PRODUCT CHANGE NOTIFICATION

PCN No.: PCN180401

TUV Certification for GNR Models

Current Version

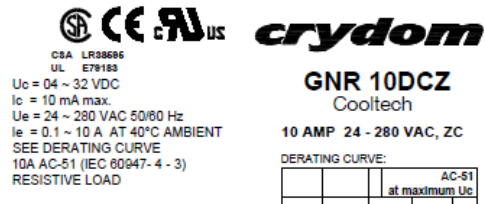
All the GNR series Solid State Relays were originally certified by TUV against standard **EN 60950**. However, TUV stopped supporting this standard a few years ago and they can't no longer update the existing certificate.

In light of this it was decided to remove the TUV marking from these products and to update the corresponding datasheets by removing any reference to TUV.
